# intel® Technical Advisory

TA-0675-3

December 15, 2003

## Intel® Telco and Industrial Grade Server TIGPR2U 500W AC Power Supply Failure Rate Above Average

## Figure A

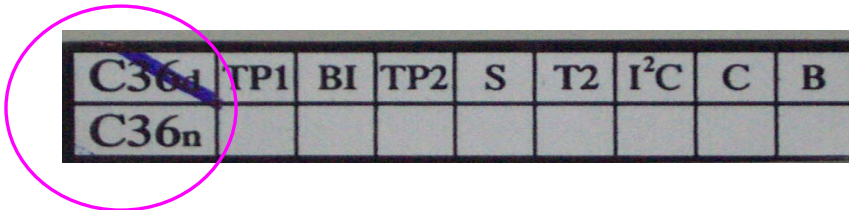
Power supply modules with the listed date codes and serial number ranges listed below have been reworked with a screened diode. The reworked power supply's can be identified with a blue tracking label mark " on the power supply production tracking label in either "C36d" or "C38d" (Figure A) box that is located on the release handle (figure B) of the 500W module.

(Note: Either "C36d" or "C38d" will have a blue slash if the power has been reworked. If there is **NOT** a slash mark in either "C36d" or "C38d" boxes and there are markings in other boxes the power supply has **NOT** been reworked.
